NOTICE TO CONTRACTORS BIDDING THIS PROJECT

Project Title: Building and Site Improvements at 6741 Downing Avenue, Bakersfield, CA

Contract No: 26016

ADDENDUM No. 5

JOB 7006	AC/2N	A212B
DP	GF	
PM	GF

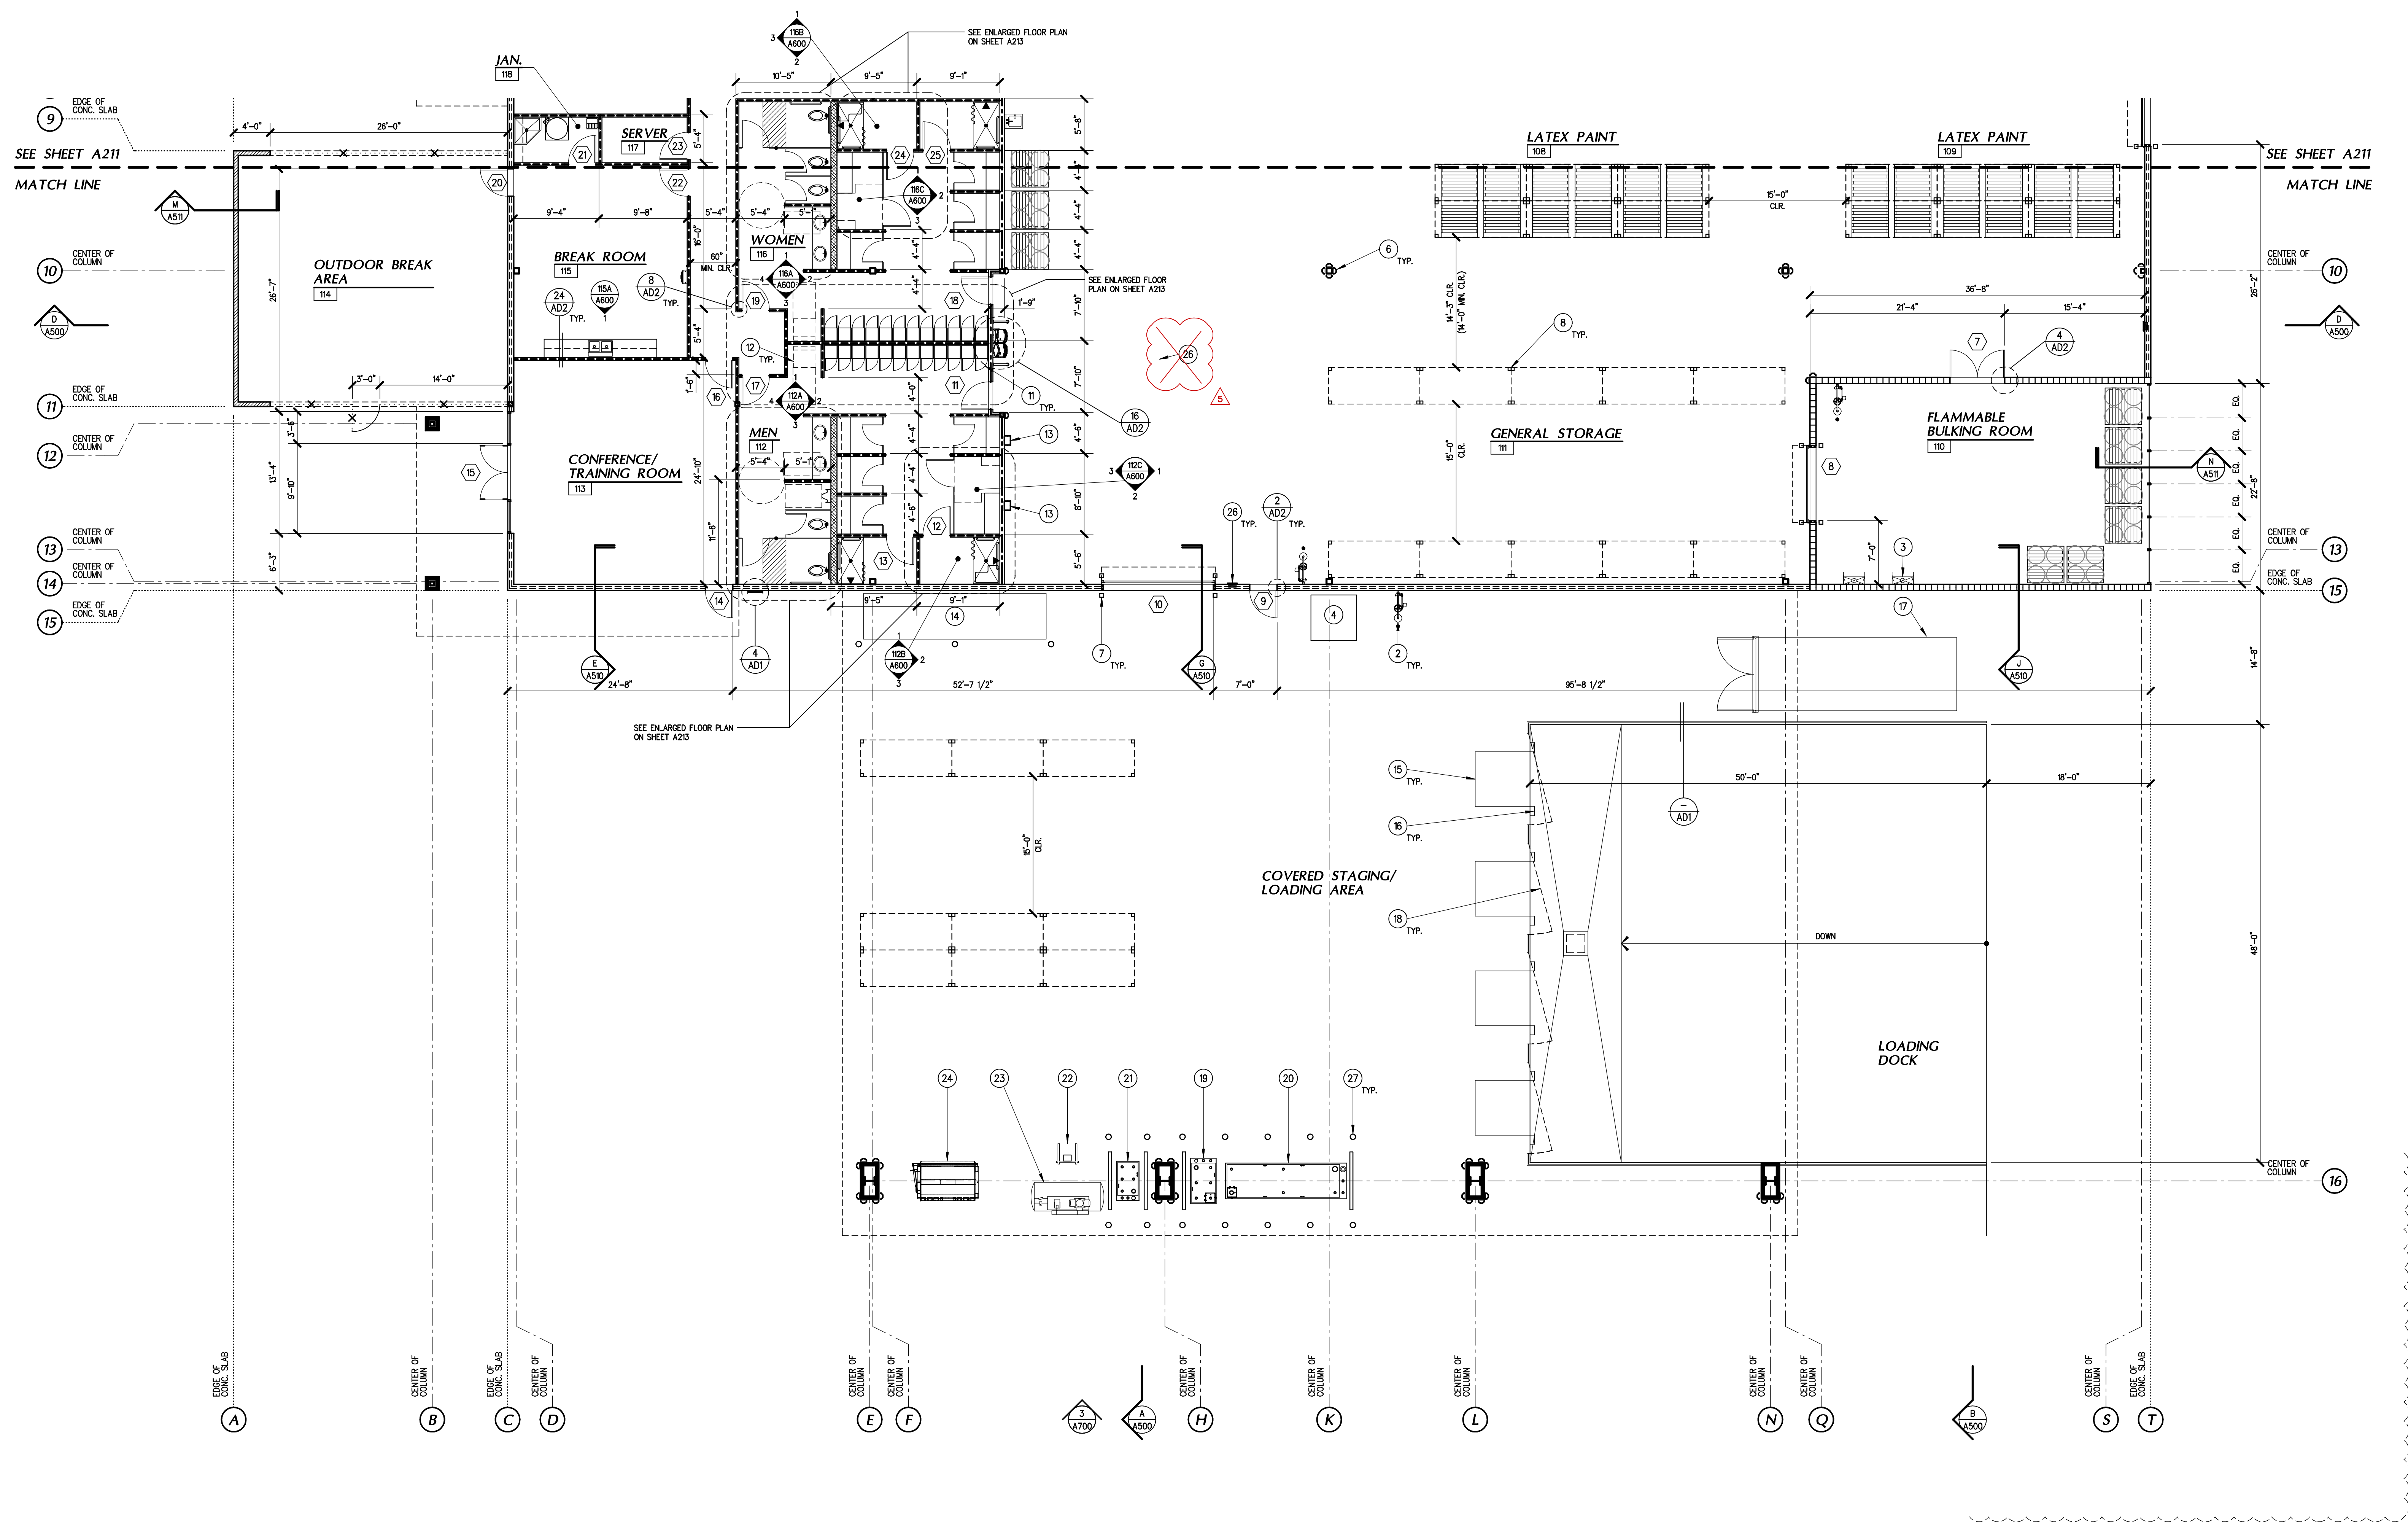
- h. Sheets A211A and A212A have been replaced with sheets A211B and A212B. Keynote #26 has been clarified. Items shown as "by owner" and "by others" have been clarified to be provided and installed by the contractor. Storefront finish has been updated. Fire extinguisher specification and locations have been added. Storage shelving information has been added. Bollard information has been added. The revised sheet is attached to this addendum.

JOB 7005	DP AC/YN	FM GUF	A311A
----------	----------	--------	--------------

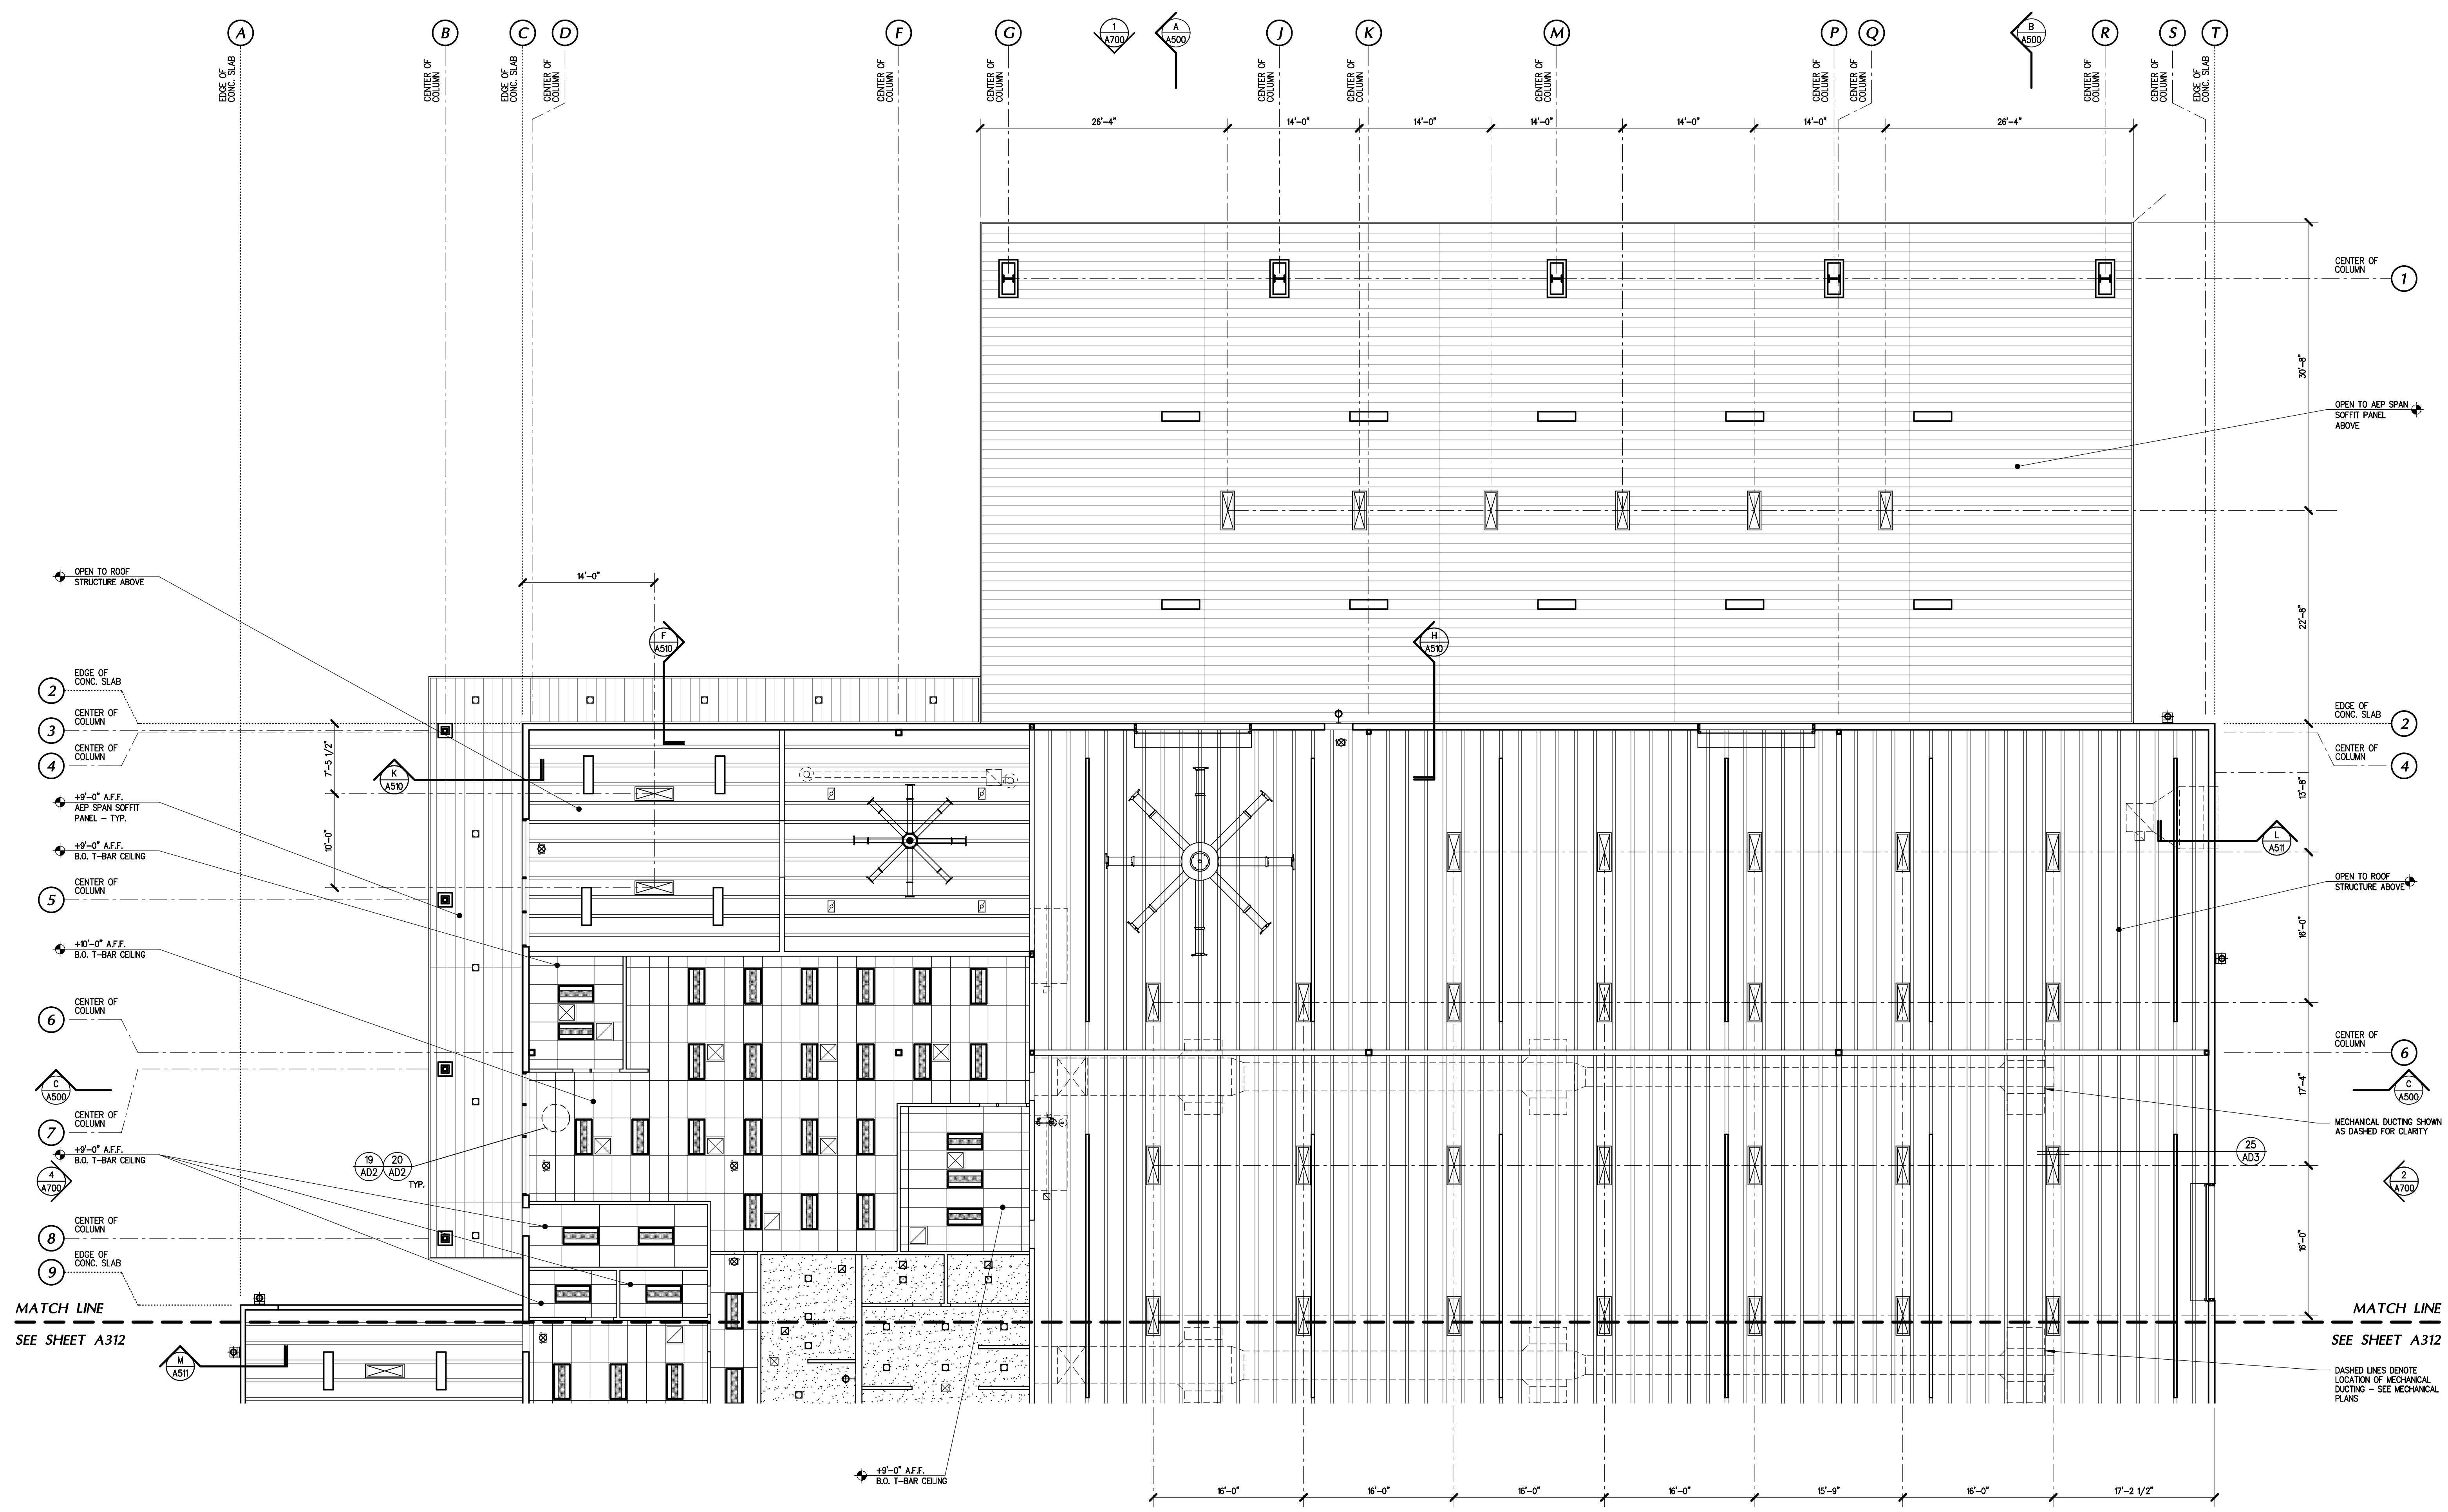
- j. Sheets A311 and A312 have been replaced with sheets A311A and A312A. Ceilings fans have been clarified to be provided and installed by the contractor. The revised sheet is attached to this addendum.

JOB	7005
DP	AC/AY
PM	GF
	A700A

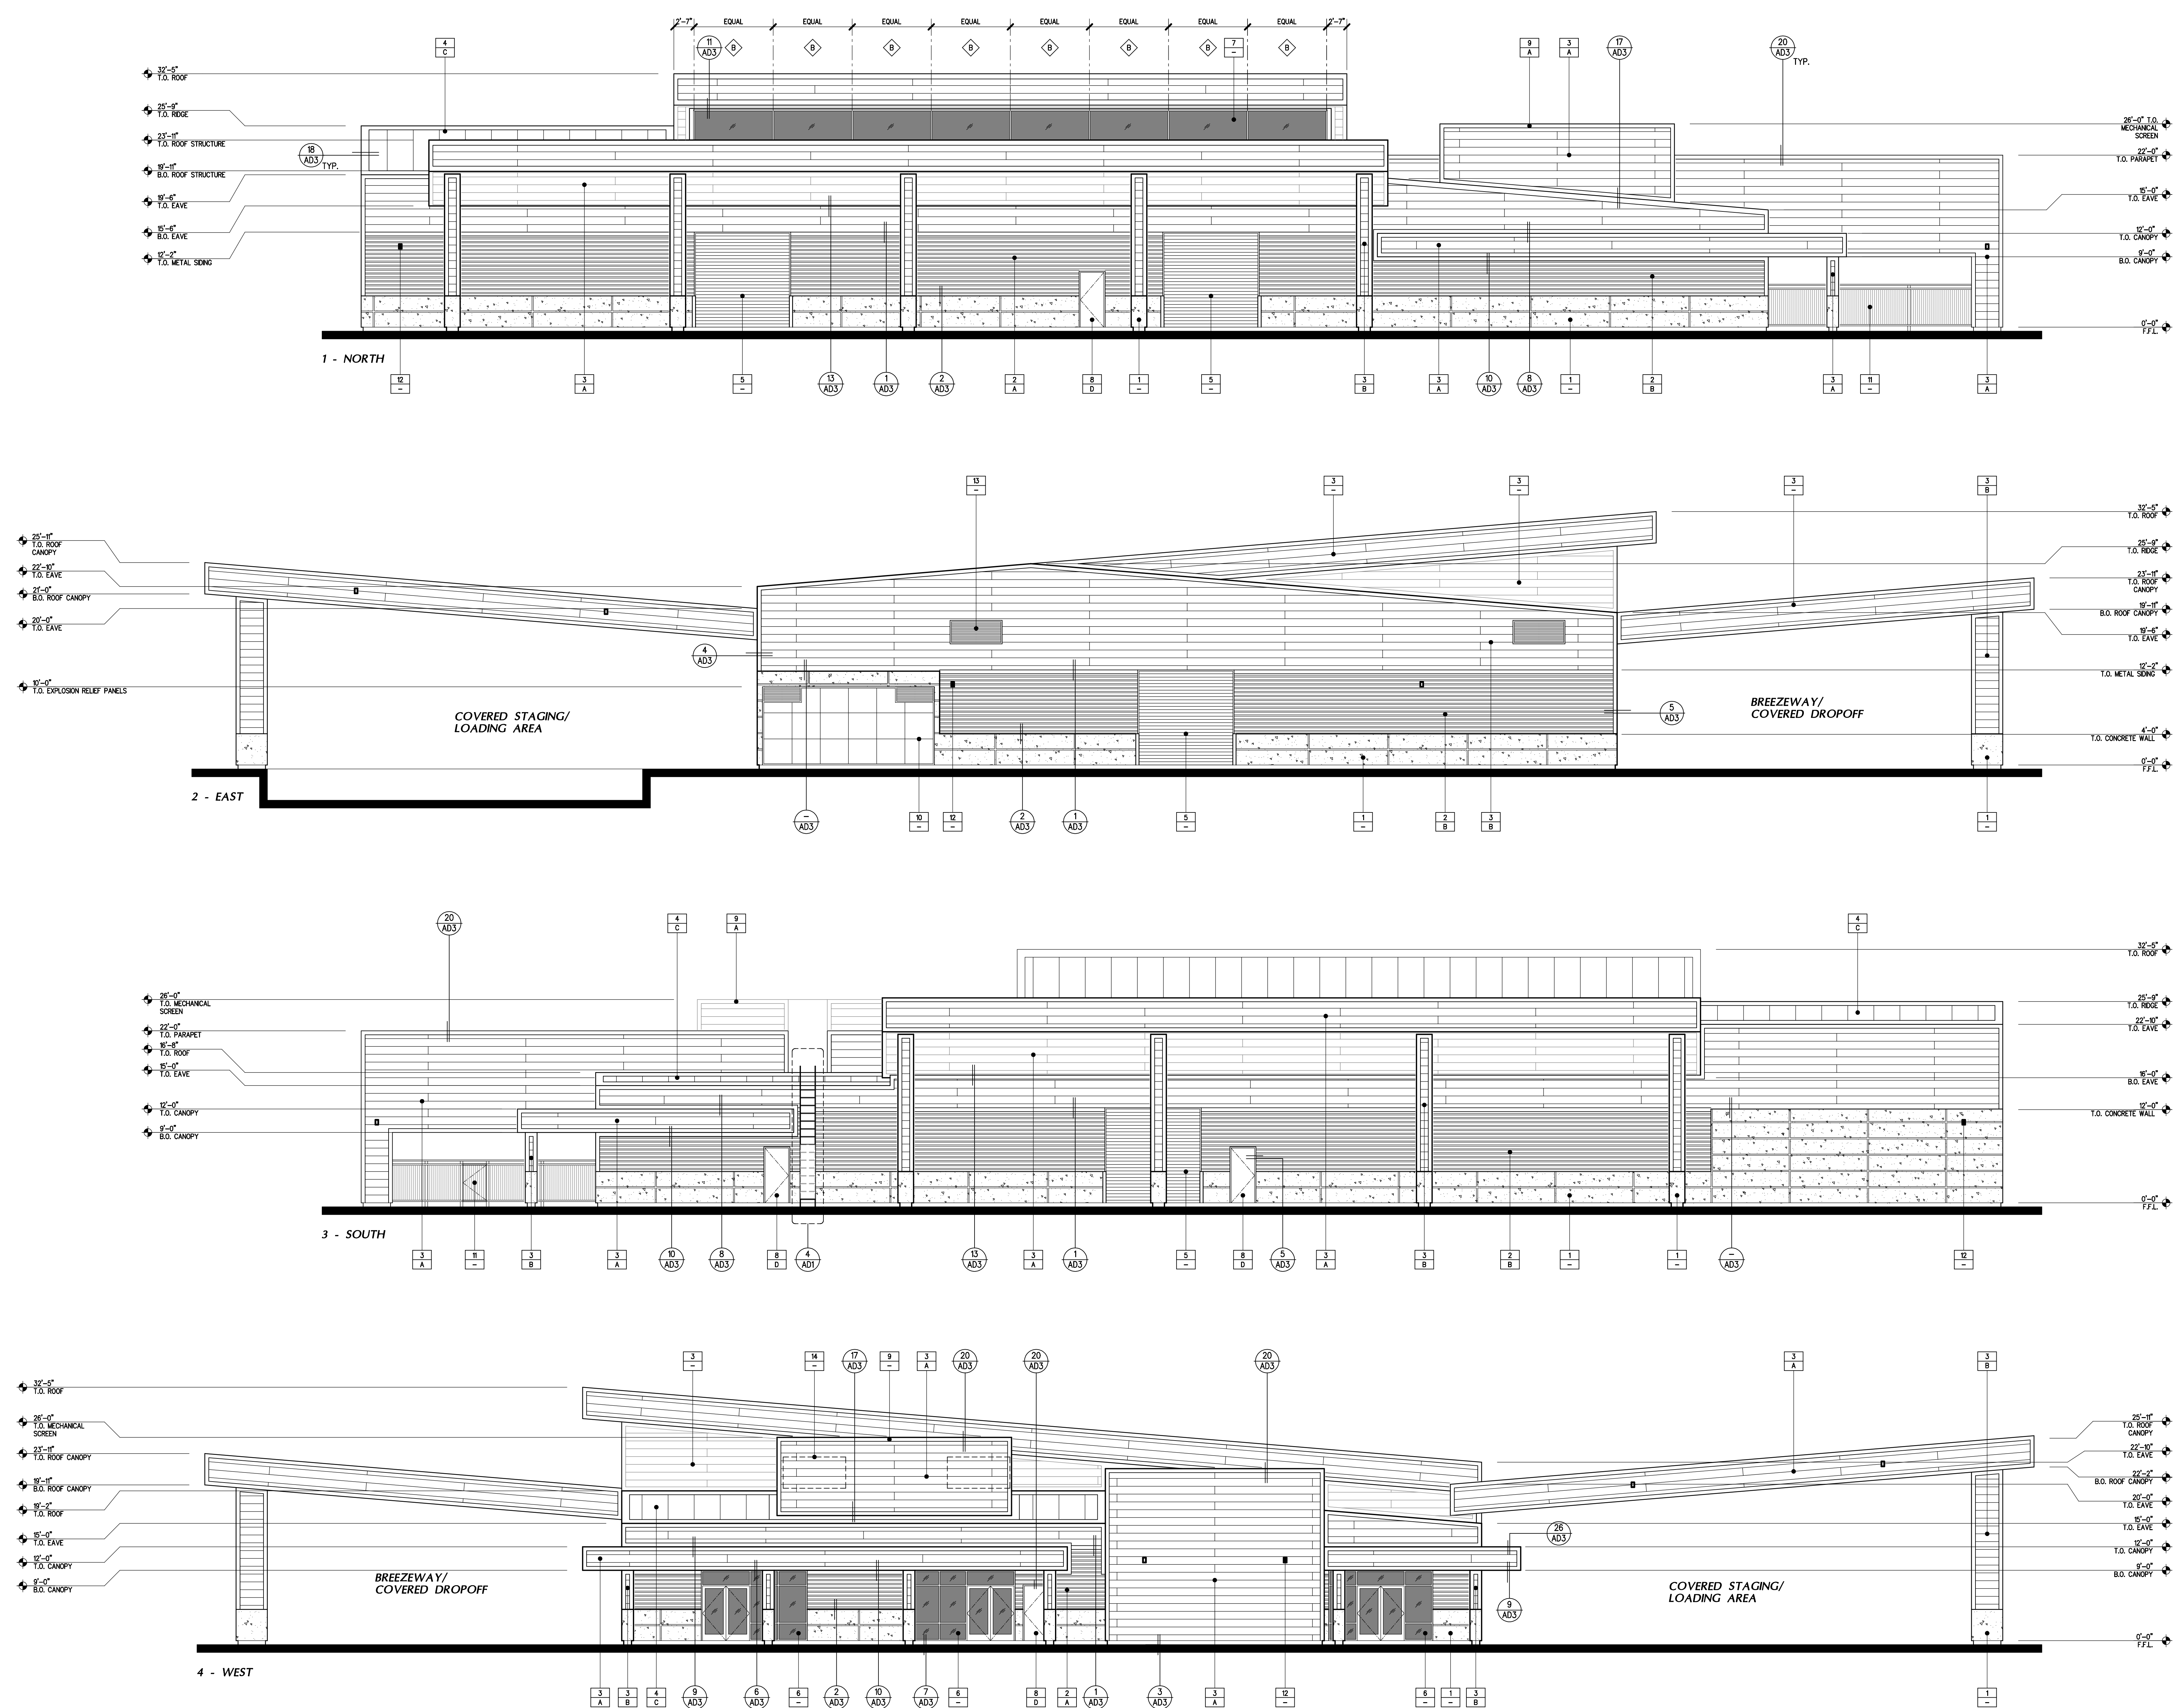
- k. Sheet A700 has been replaced with sheet A700A. Explosion relief panel information has been added. Color of exterior metal wall panel system has been revised. The revised sheet is attached to this addendum.
